June 5, 2002

AEP:NRC:2075
10 CFR 50.90

Donald C. Cook Nuclear Plant Units 1 and 2
FINAL RESPONSE TO SECOND NUCLEAR REGULATORY
COMMISSION REQUEST FOR ADDITIONAL INFORMATION AND
VERBAL CONCERNS REGARDING LICENSE AMENDMENT REQUEST
FOR CONTROL ROOM HABITABILITY

Figures 1 through 5 in Attachment 3 to this letter show the plant response for a Unit 2 locked rotor event. These figures are also representative of the Unit 1 plant response.

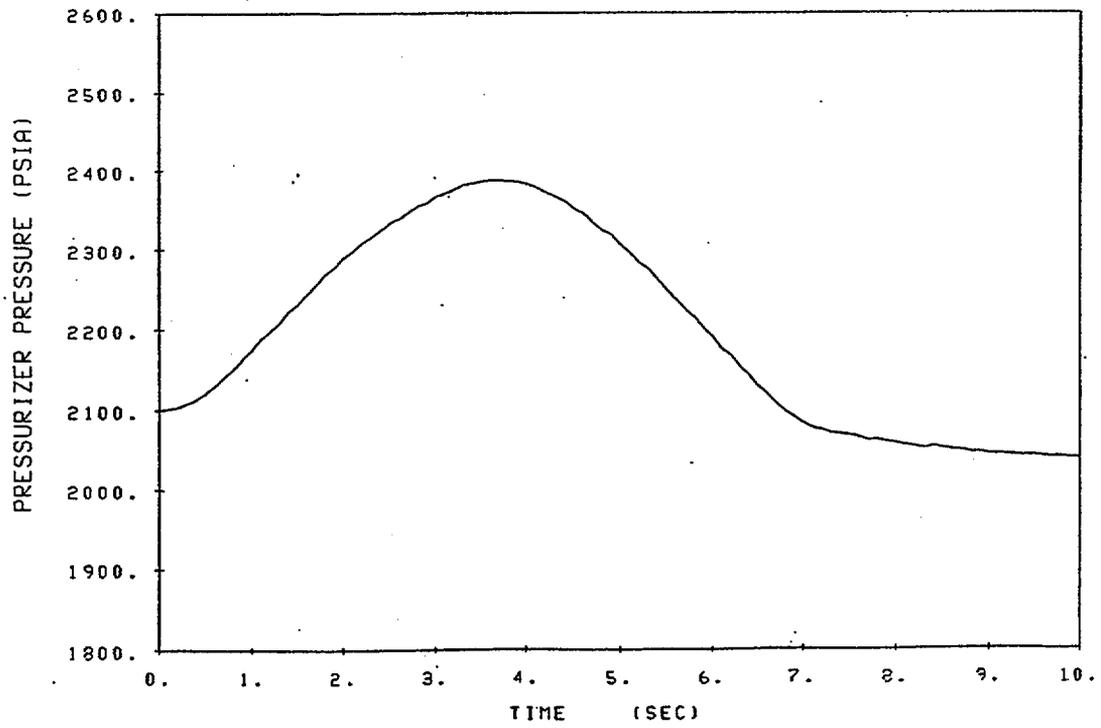
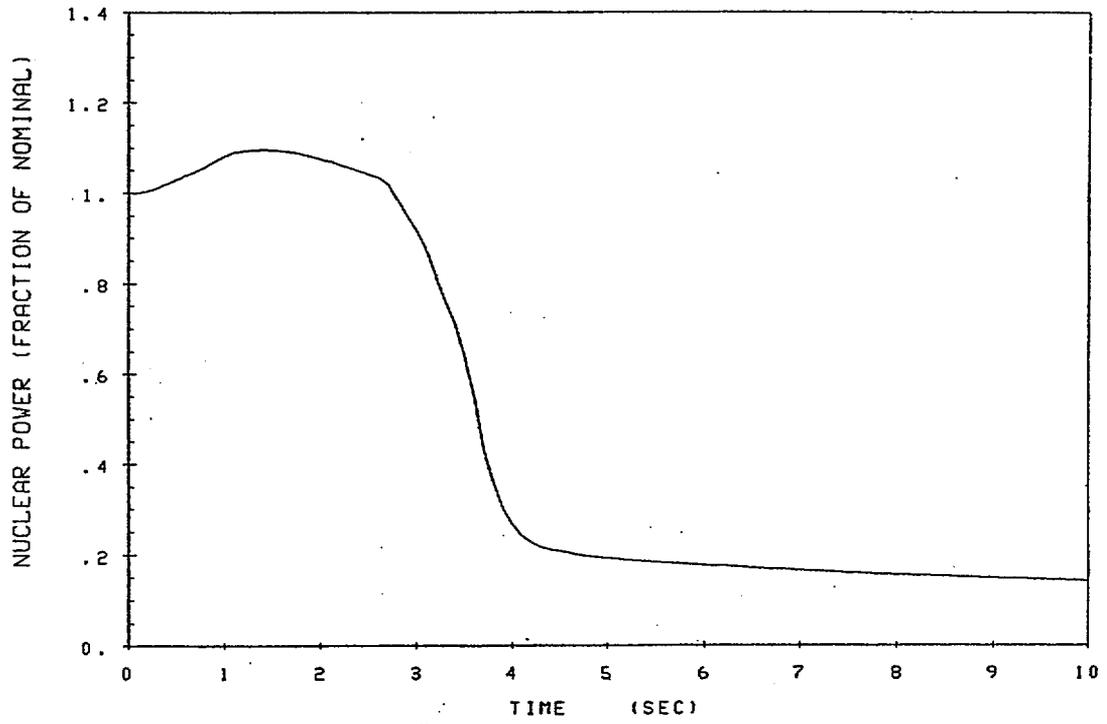
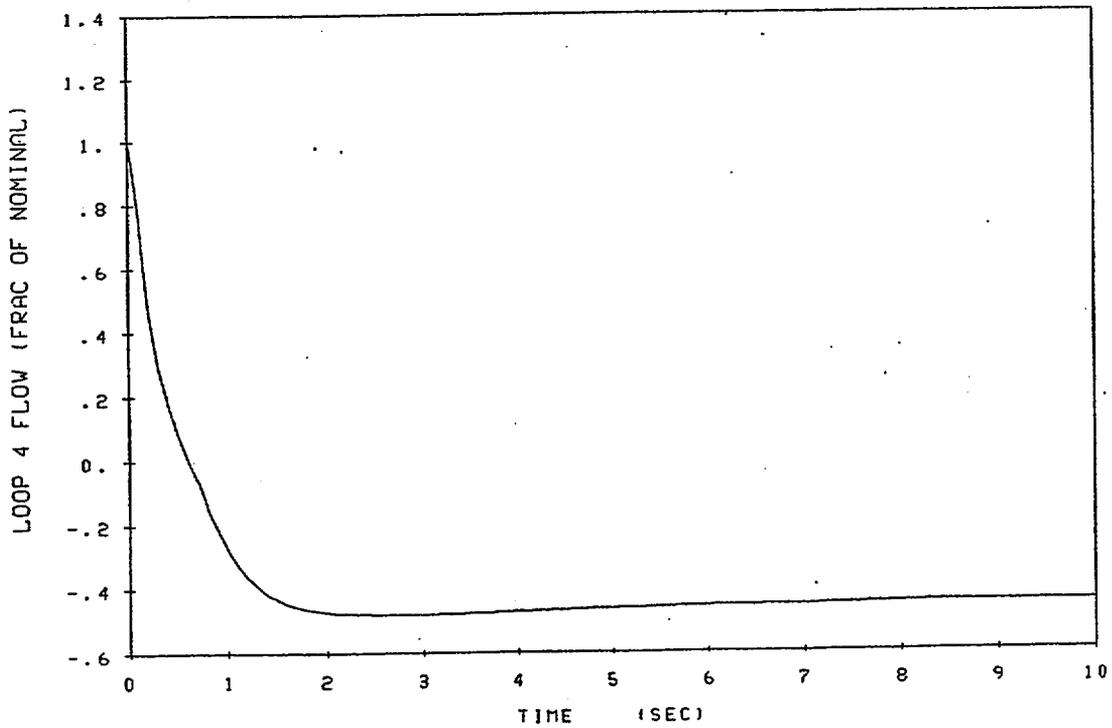
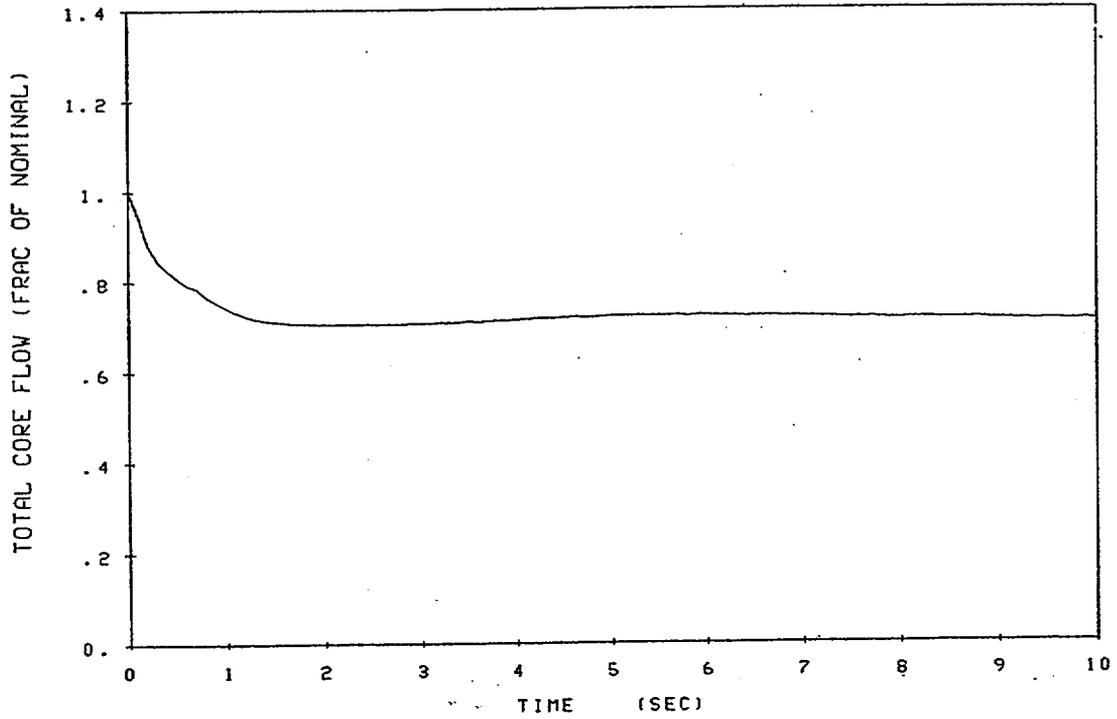
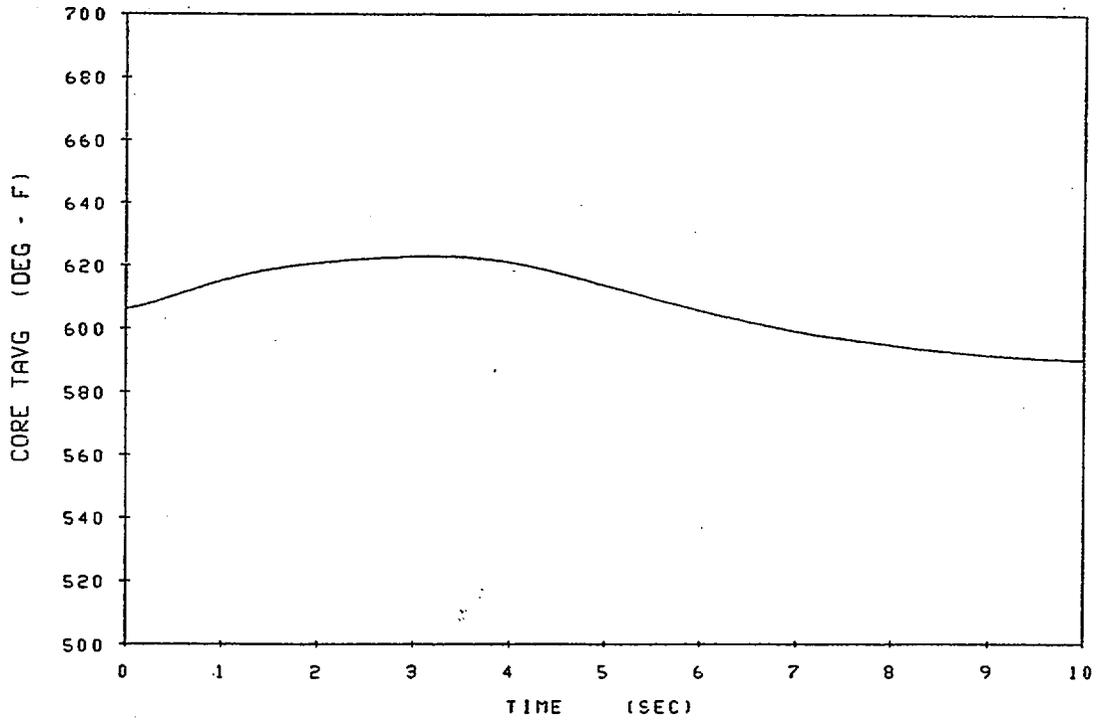
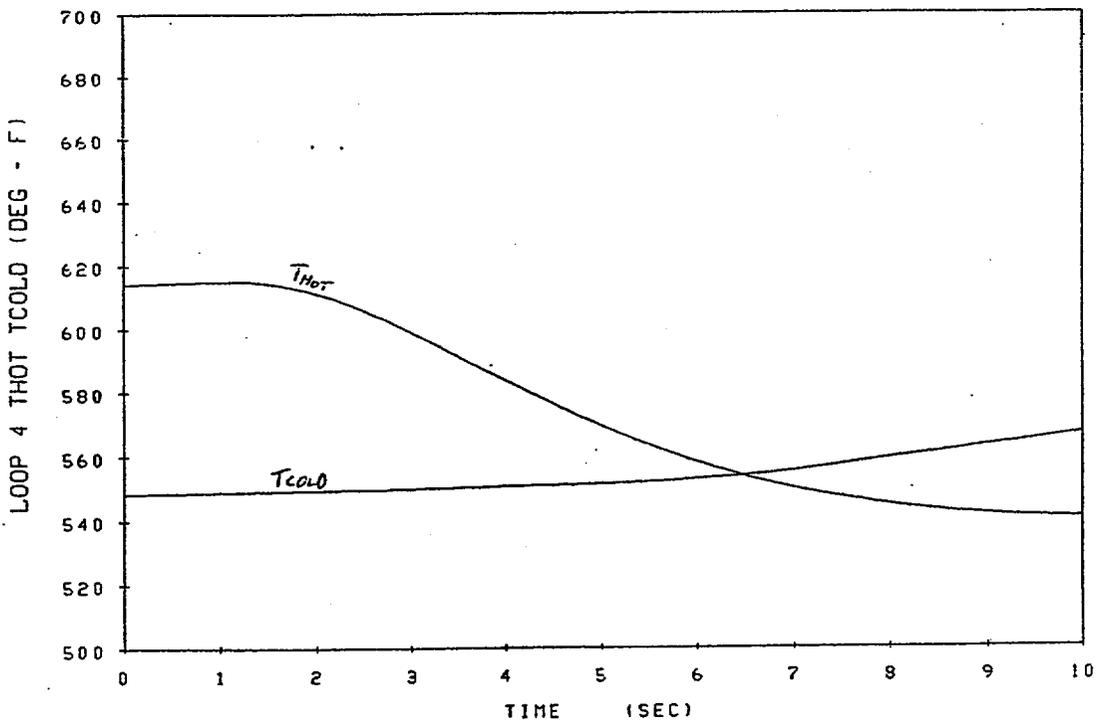
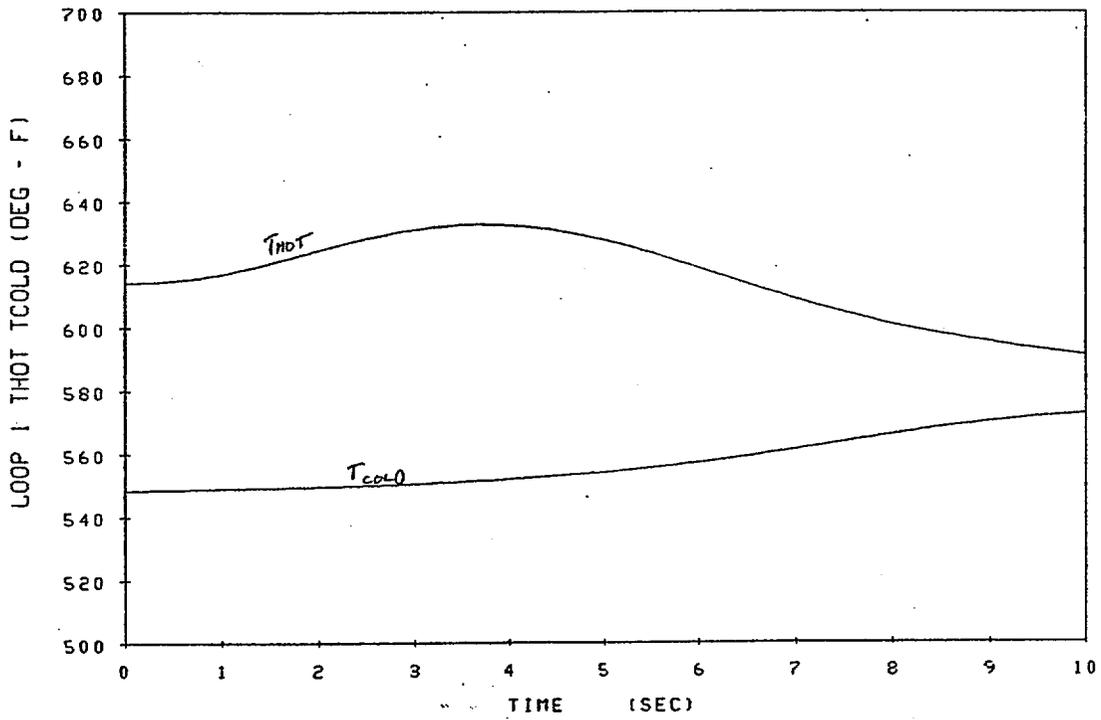
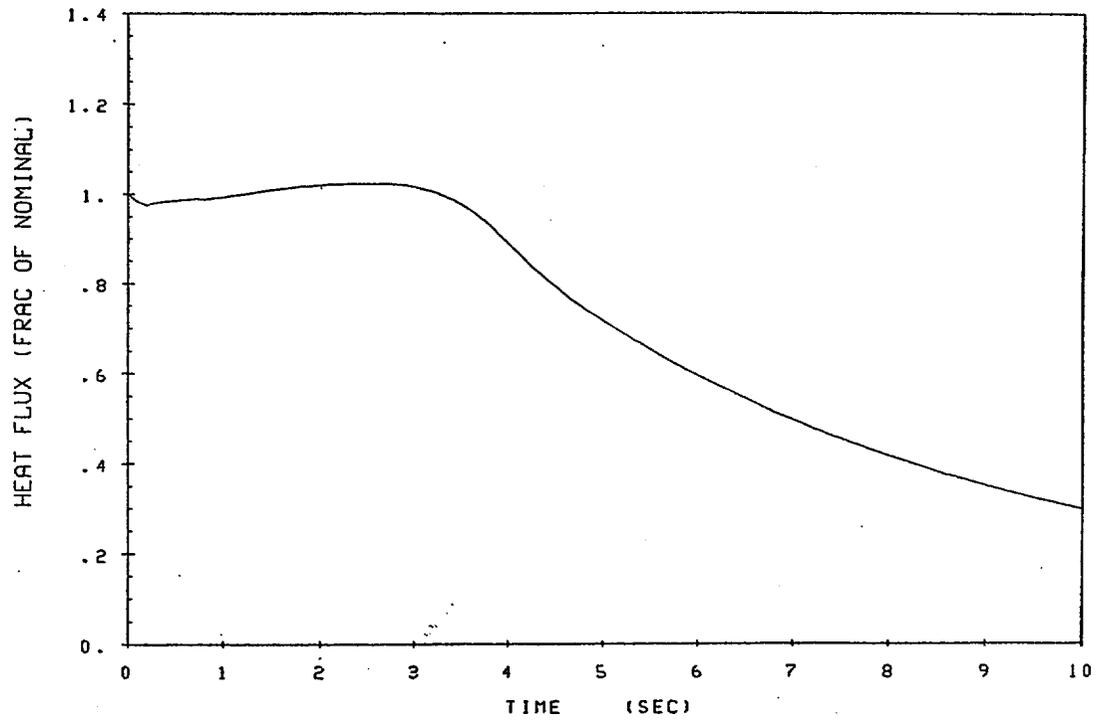
In order for the staff to continue its review of the locked rotor event described in your application, the staff will need the following additional information: (1) a description of and justification for the initial assumptions used in the new analysis, (2) a comparison of the differences in assumption between the previous and new analyses, (3) the sequence of events for the new analysis, and (4) the results of the analysis including plots of important parameters to show plant response and minimum DNBR.

(4) The results of the analysis including plots of important parameters to show plant response and minimum DNBR.
